City of Maple Ridge
RFEI-PL18-4 – Leisure Centre Public Art Call

TO: All Bidders
DATE: March 26, 2018
FROM: Brittany Barton
On behalf of Yvonne Chui
SUBJECT: ADDENDUM # 1

Maple Ridge Leisure Centre Scope 2: Lobby/ Changeroom Upgrades

A2.00

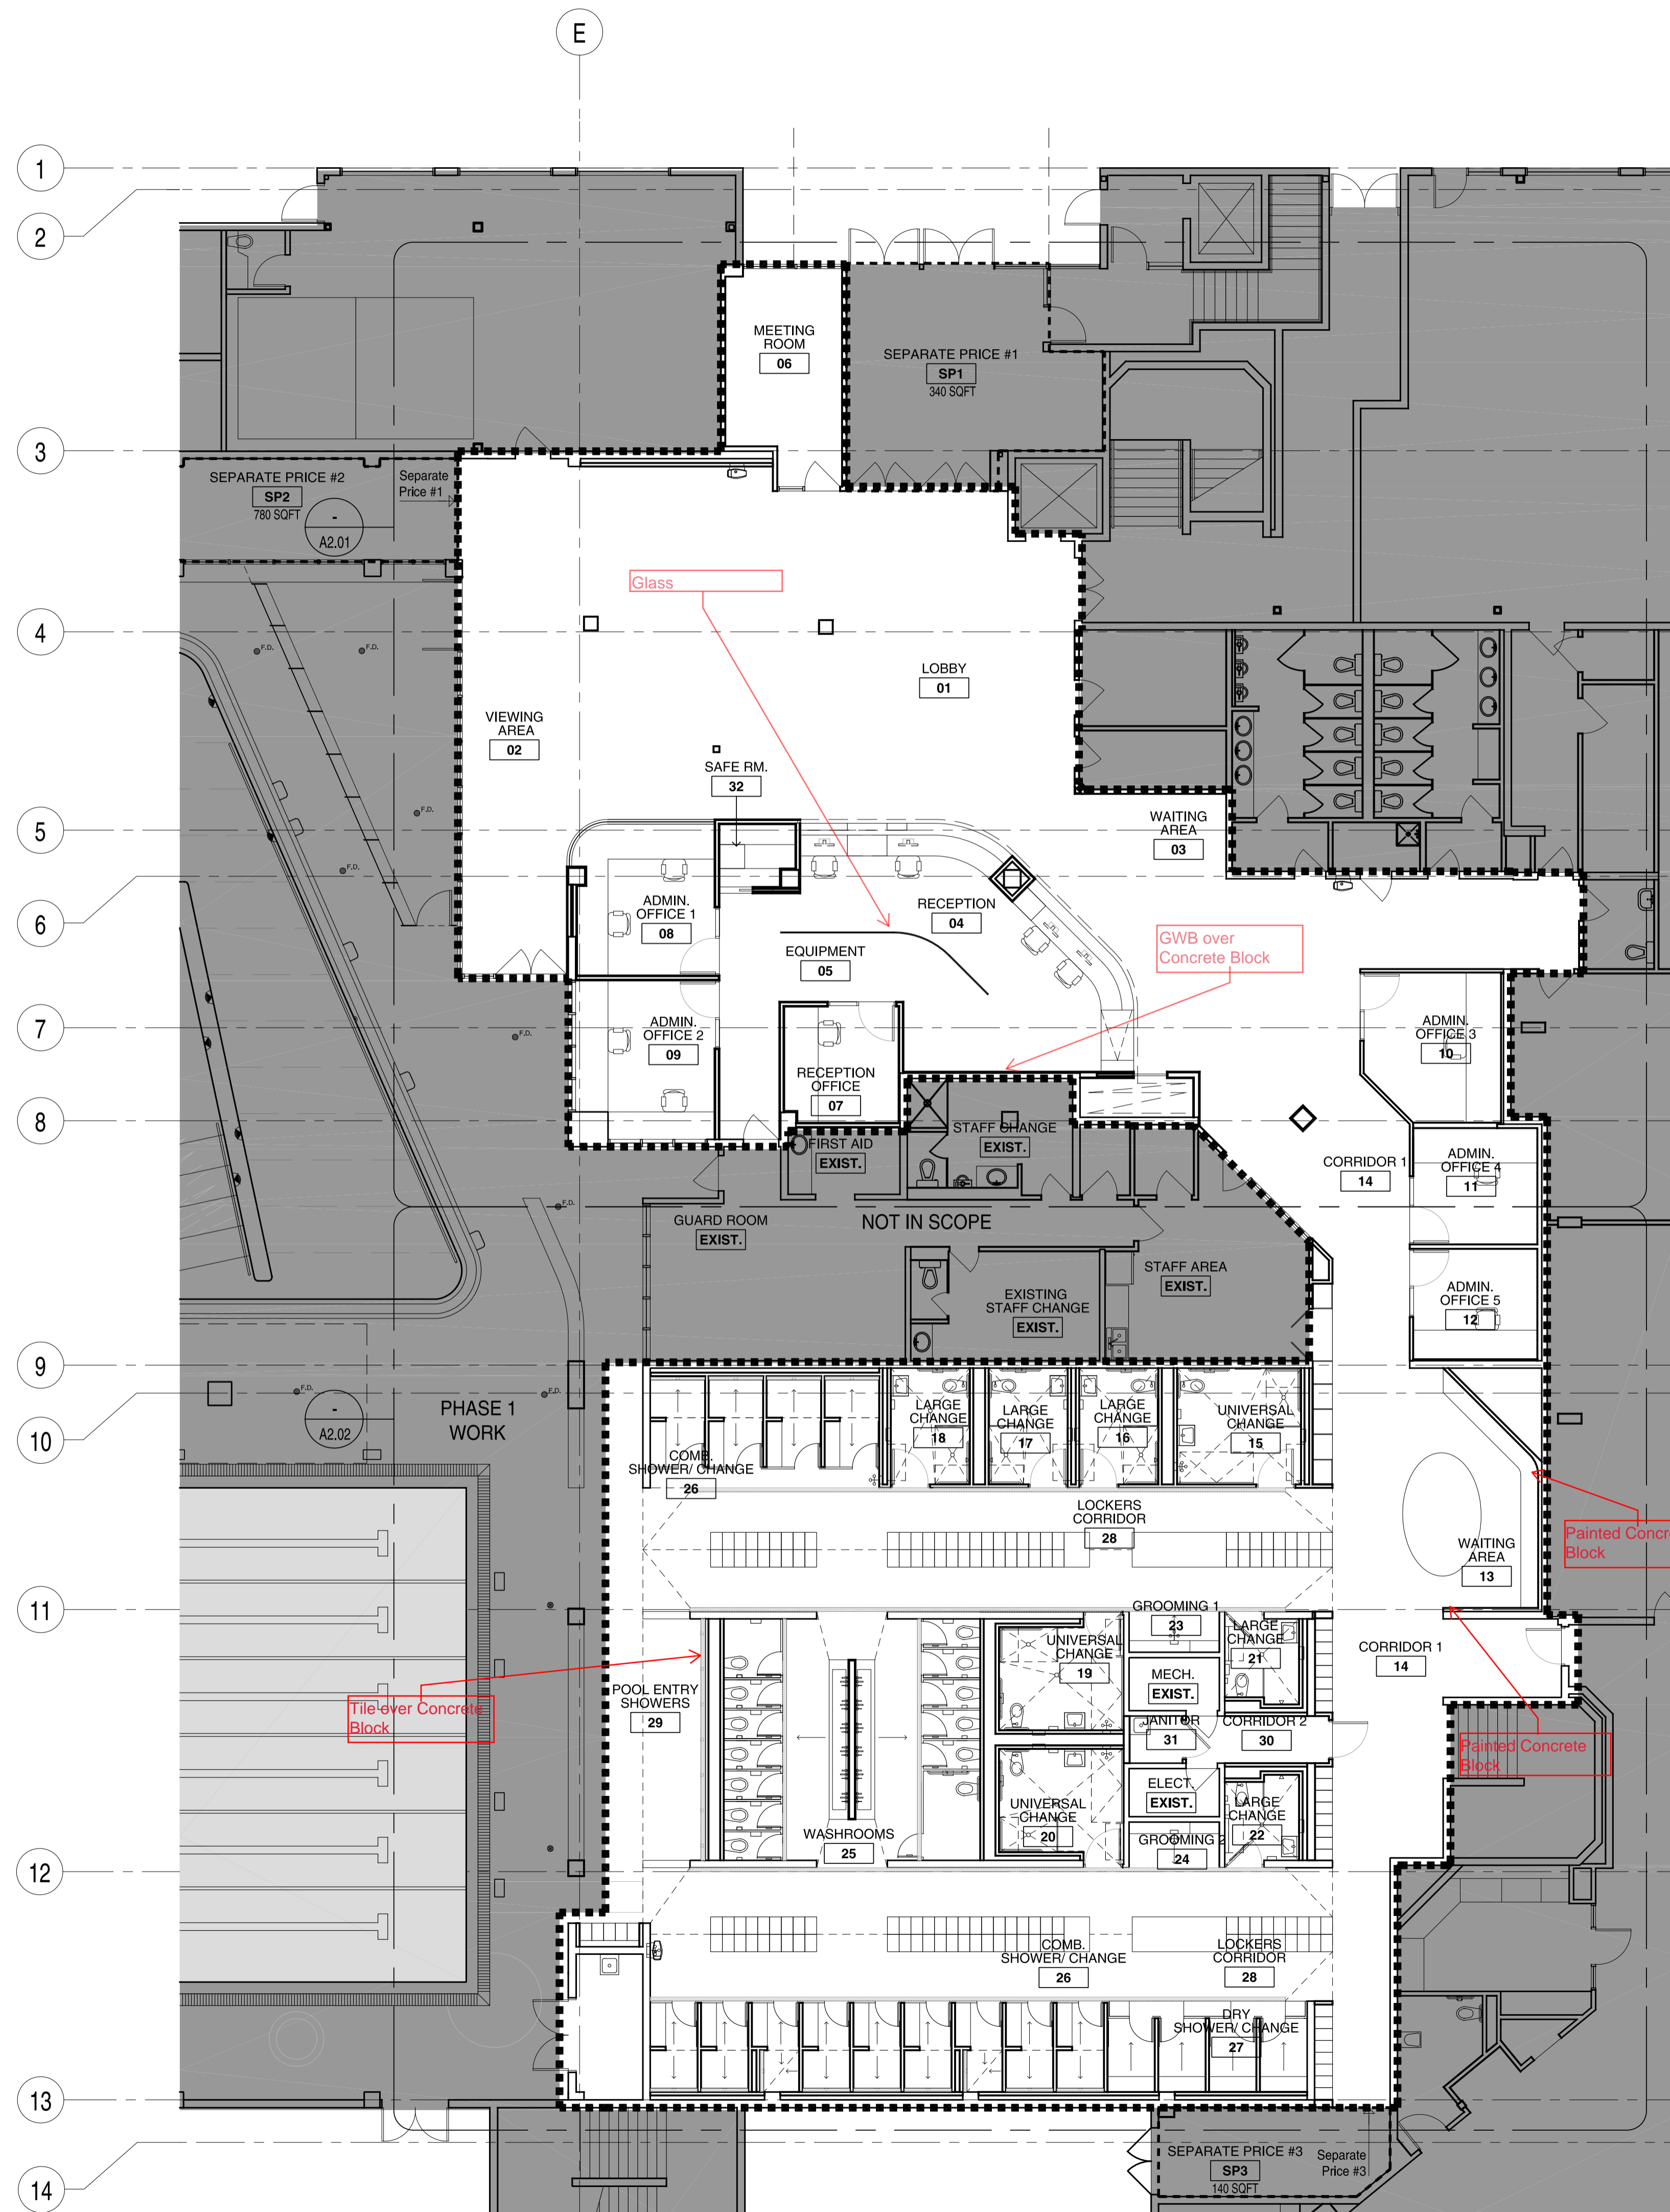
2. What is the substrate material for the three locations identified?

The substrate for the wall behind the main reception desk (location #1) is glass and gypsum wall board over concrete block; the wall of the waiting area outside the universal change rooms (location #2) will be painted concrete block; the feature shower wall on the pool deck (location #3) will consist of tile over concrete block. See map below with notes in red boxes.

6. On page 3 of the EOI further details provided about location #3: the feature wall on the pool deck is recessed as per the drawing. In addition, approximately 6 shower heads will be installed into this wall for users. Therefore any proposed artwork needs to take water, durability, maintenance and aesthetics for the life of the work into consideration.

The bench in front of the feature shower wall may be part of the proposed artwork, if appropriate. The bench will be made of tile over concrete block.
